**PURPOSE:** To communicate two upcoming changes to the I-Series Plus Combi and Heat-Only Installation and Operation Manuals.

- Applicable Product: Rinnai I-Series Plus Condensing Boilers (Combi and Heat-Only)
- Applicable Models:
  - **Combi Models:** IP060160C, IP090099C, IP090160C, IP090199C, IP120199C, IP150199C, IP175199C, IP199199C
  - **Heat-Only Models:** IP060S, IP090S, IP120S, IP150S, IP175S, IP199S

Figure 1

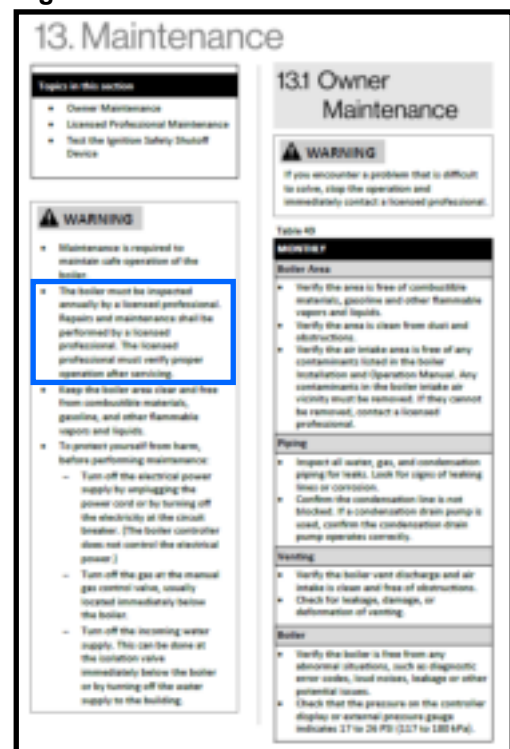
The first update to the I-Series Plus Boiler Combi and Heat-Only Installation and Operation Manual applies to section “13. Maintenance” (Figure 1).

In the second bullet point in the “Warning” section, the terminology “must be” and “must verify” are changing to “is recommended to.” For example:

"The boiler **must be** inspected annually by a licensed professional. Repairs and maintenance shall be performed by a licensed professional. The licensed professional **must verify** proper operation after servicing."

"The boiler **is recommended to** be inspected annually by a licensed professional. Repairs and maintenance shall be performed by a licensed professional. The licensed professional **is recommended to** verify proper operation after servicing."

Figure 2

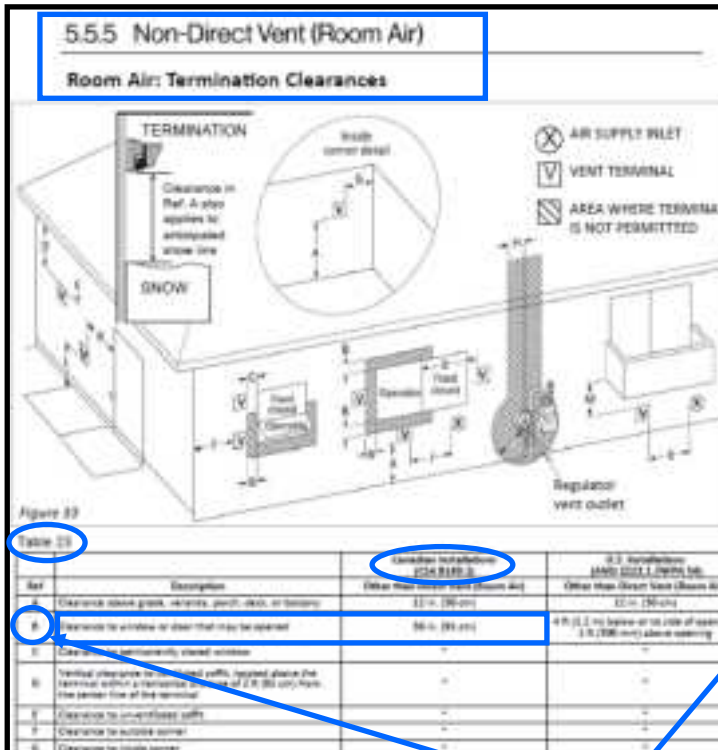
- **Section in Manual: 5.5.5 Non-Direct Vent (Room Air) Termination Clearances**
  - Table 23, Reference B (Clearance to window or door that may be opened) (Figure 2).
- **Section in Manual: 5.5.2 Direct Vent (Concentric and Twin Pipe) Termination Clearances**
  - Table 15, Reference B (Clearance to window or door that may be opened) (Figure 3).

In both sections, Reference B for Canadian installations is being modified to reflect the new clearances as shown in the table below.

Ref	Description	Canadian Installations (CSA B149.1)
B	Clearance to window or door that may be opened	<ul style="list-style-type: none"> <li>• 6 in. (15 cm) for appliances ≤10,000 Btu/hr</li> <li>• 12 in. (30 cm) for appliances &gt; 10,000 Btu/hr and ≤ 100,000 Btu/hr</li> <li>• 36 in. (91 cm) for appliances &gt; 100,000 Btu/hr</li> </ul>

The above clearance adjustments are required to ensure compliance with the CSA B149.1 standard, as well as ensure a safe and proper installation.
